RHODE ISLAND DEPARTMENT OF TRANSPORTATION

Old Tower Hill Rd (Rt 108 - Rt 1)

NOTICE TO PROSPECTIVE BIDDERS

ADDENDUM NO. 2 Prospective bidders and all concerned are hereby notified of the following changes in the Plans, Specifications, Proposal and Distribution of Quantities for this contract. These changes shall be incorporated in the Plans, Specifications, Proposal and Distribution of Quantities, and shall become an integral part of the Contract Documents.

3. Plan Sheet 41

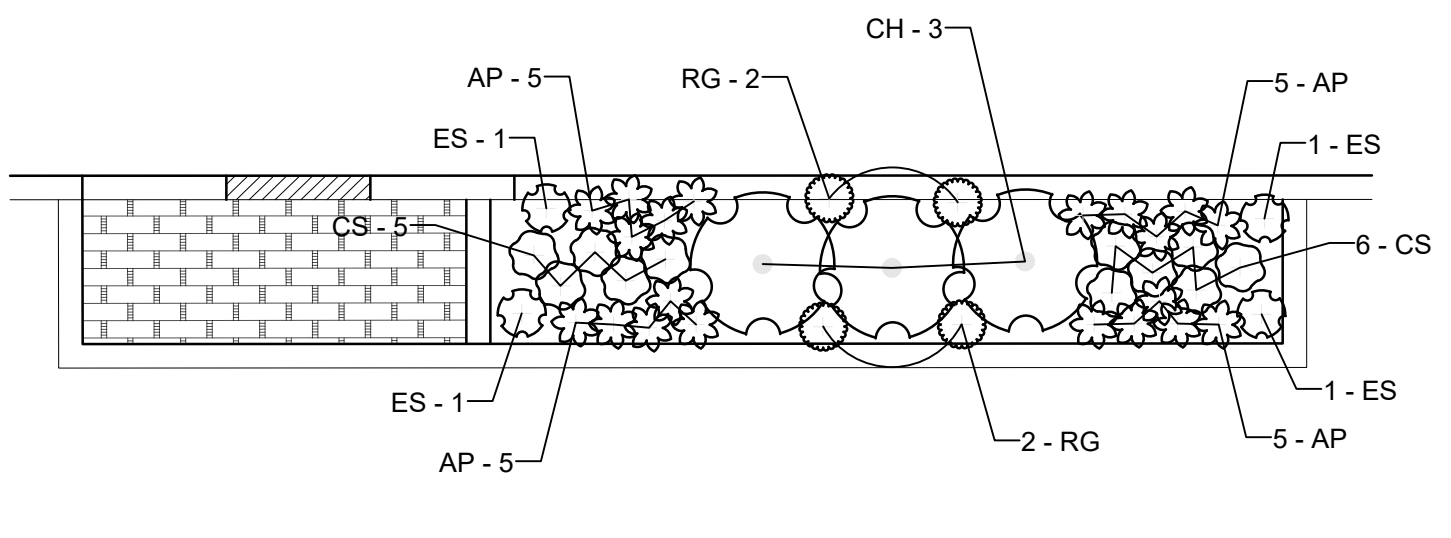
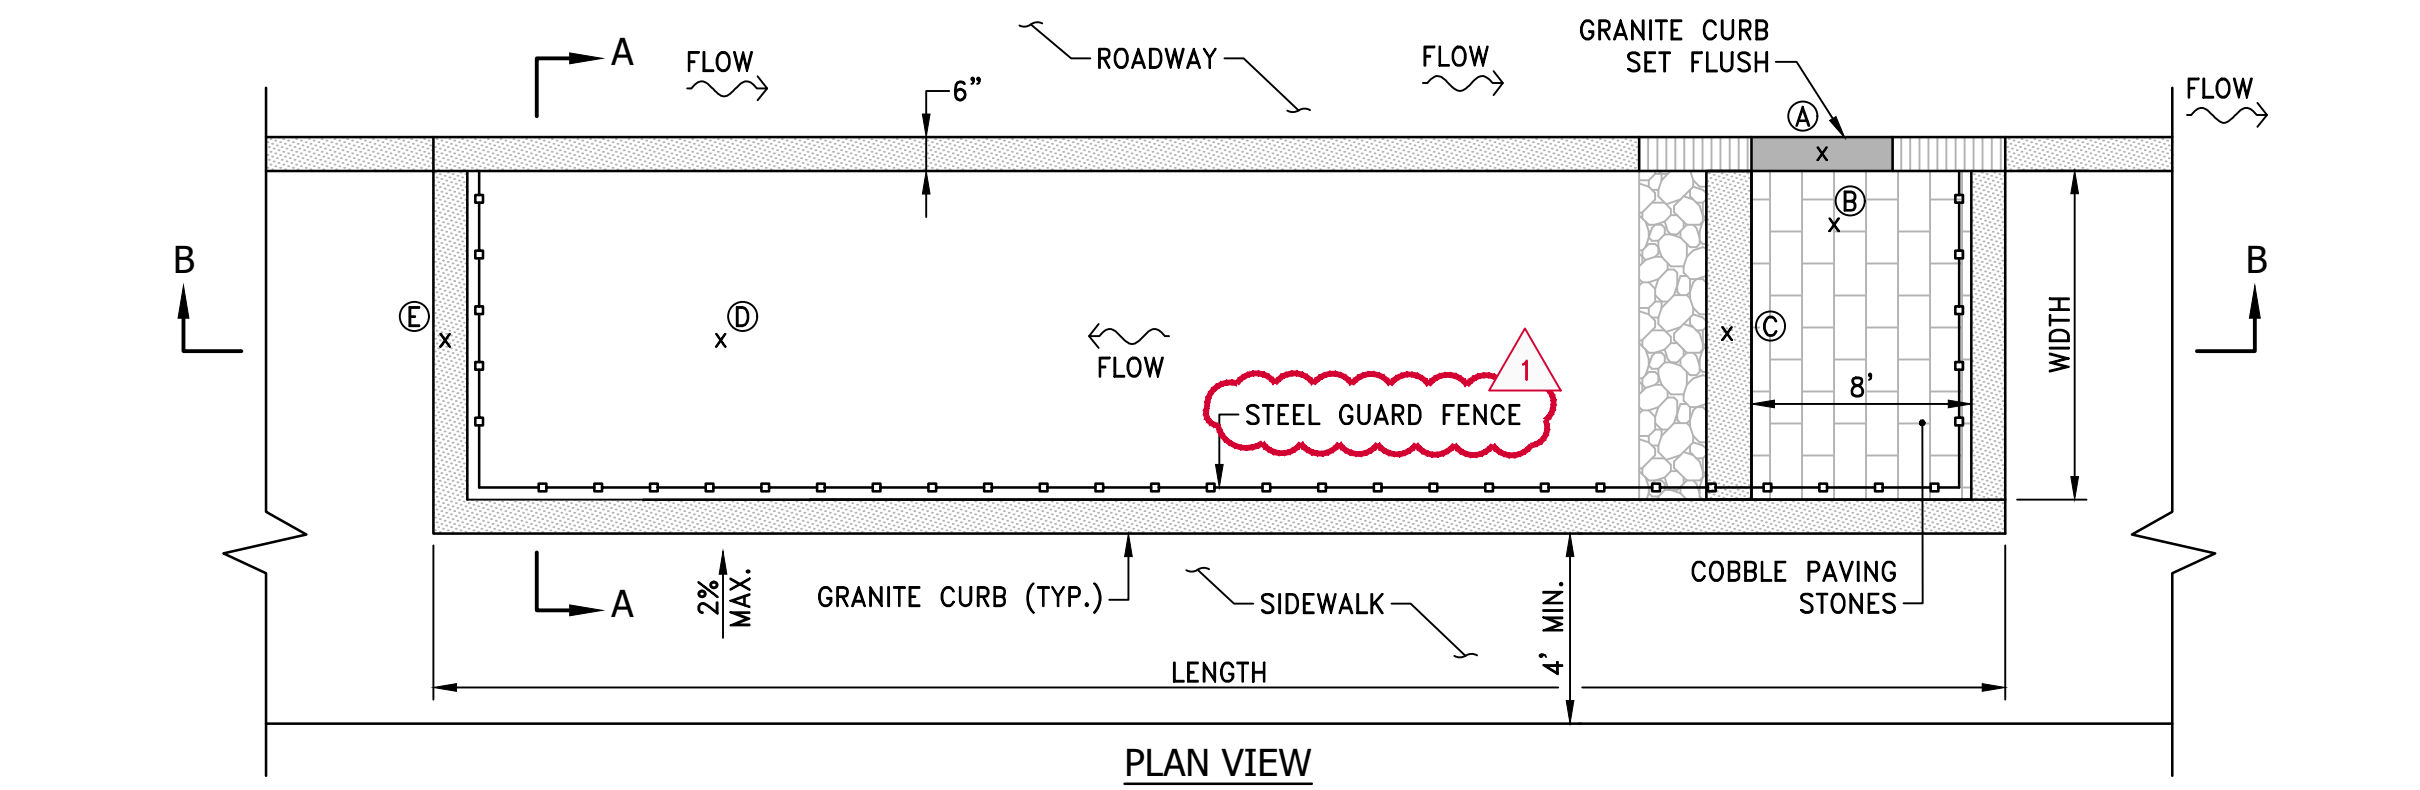
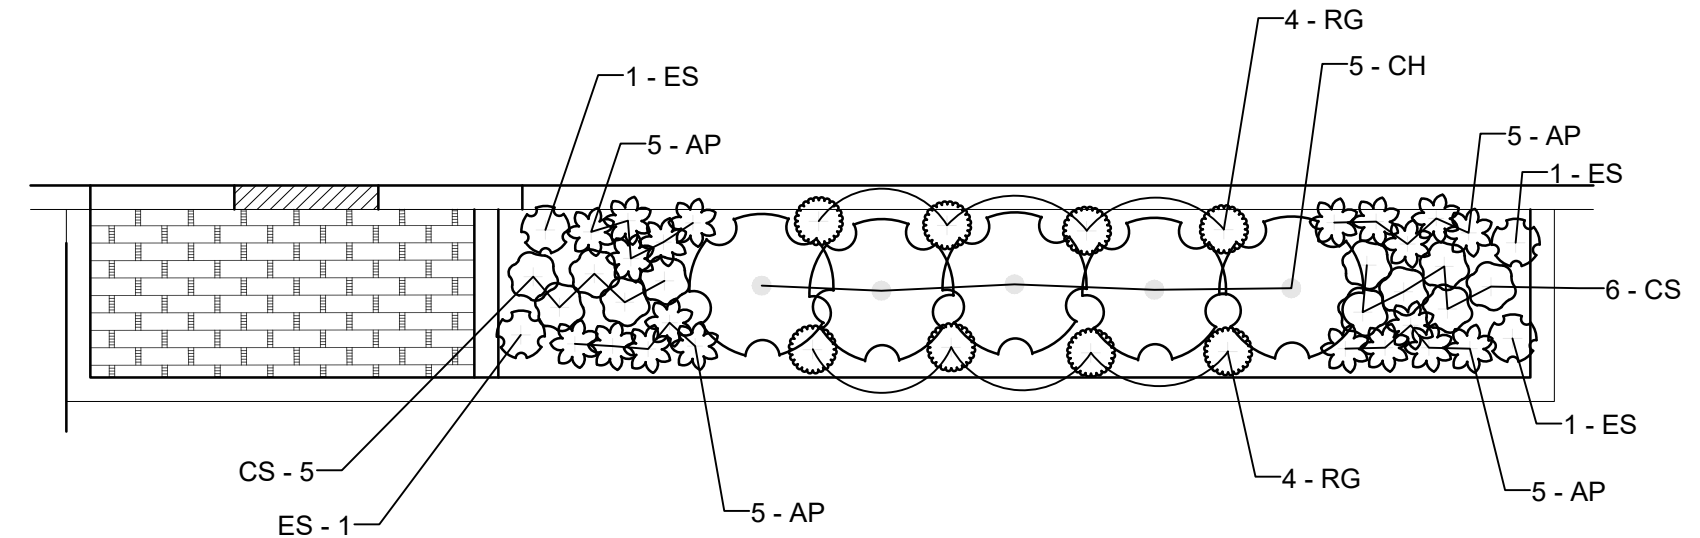
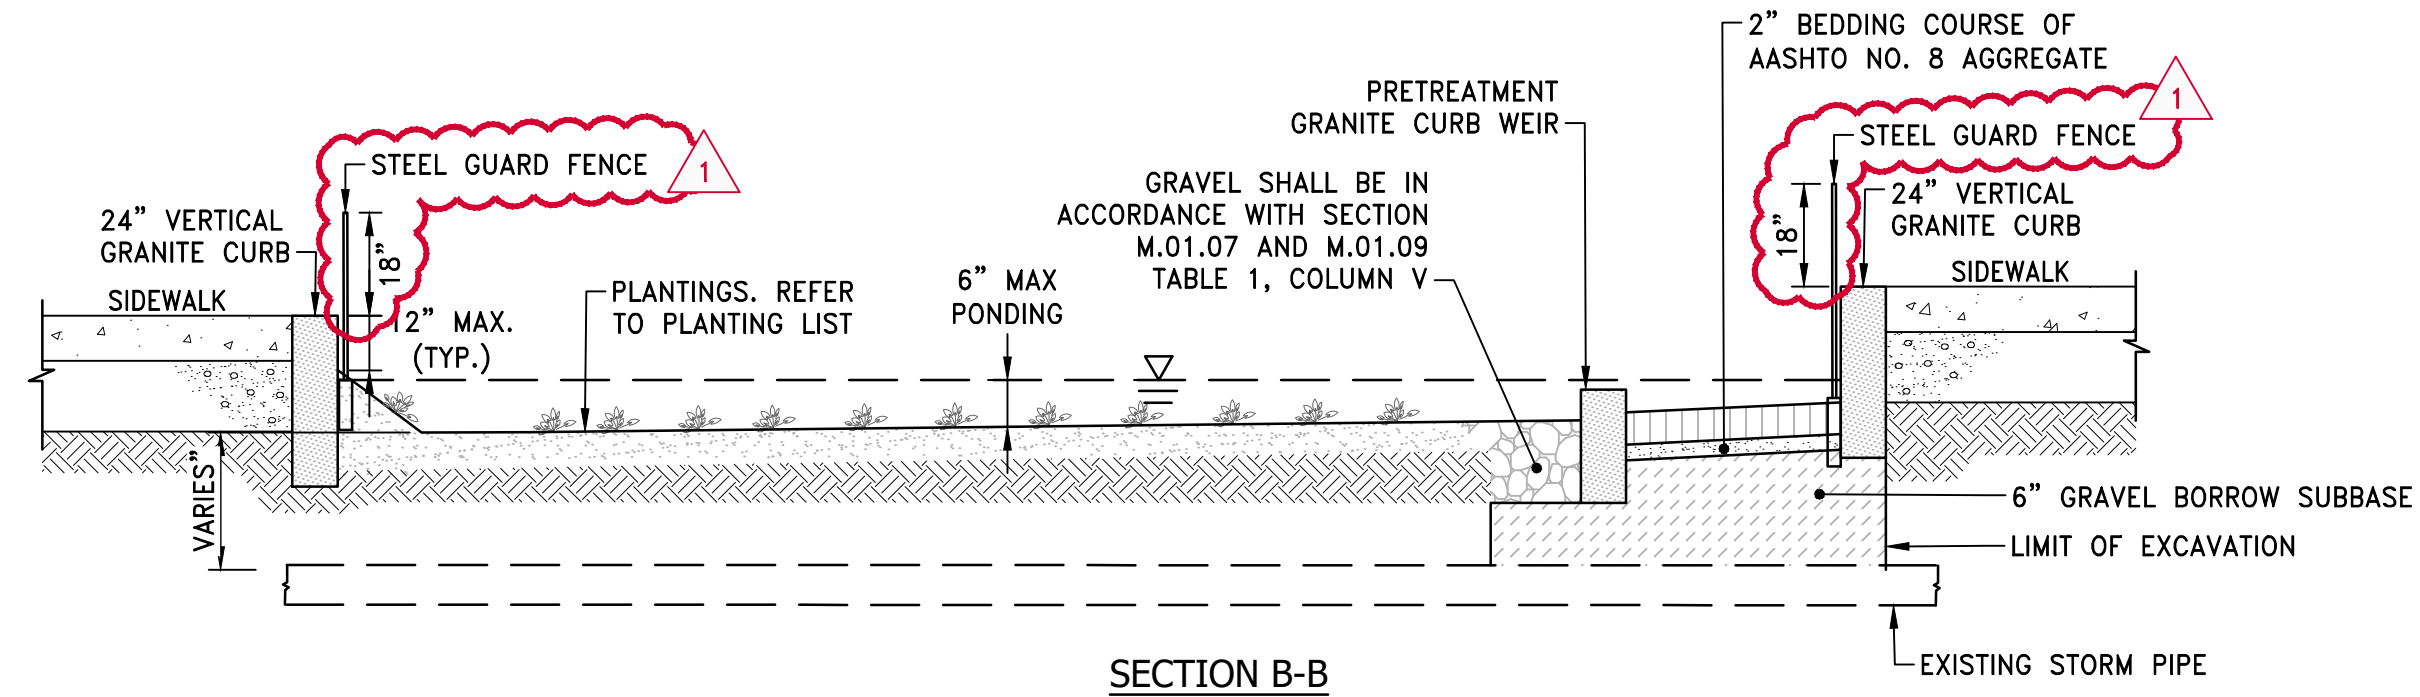
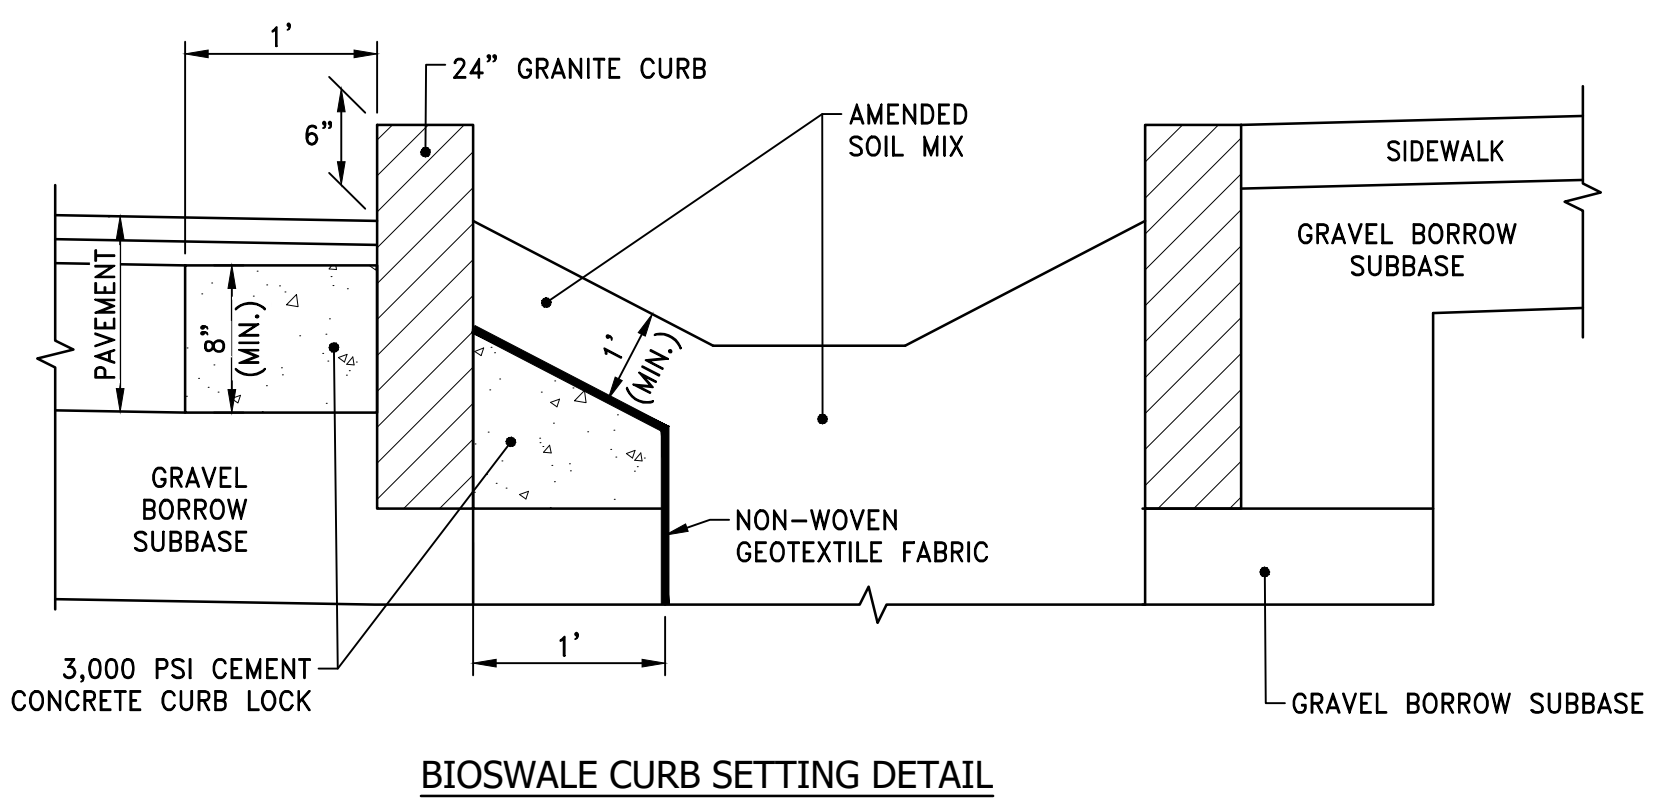
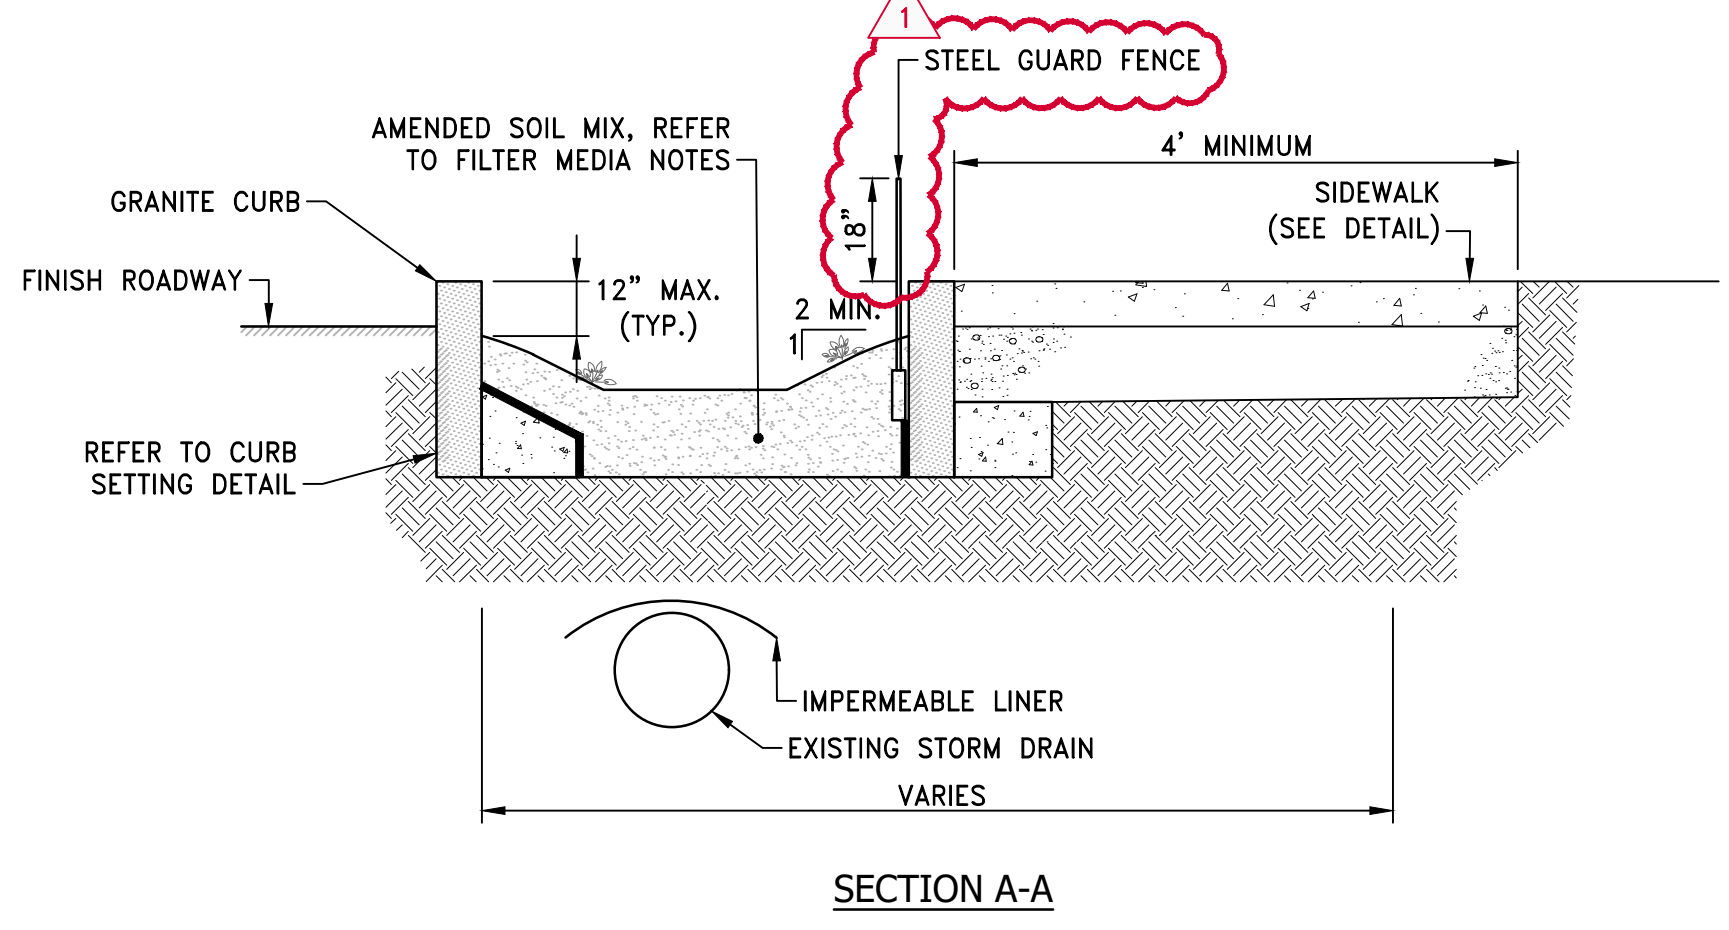
Replace Plan Sheet 41 with Sheet 41(R-1) attached to this Addendum No. 2. The bioretention curb inlet planter details have been modified.
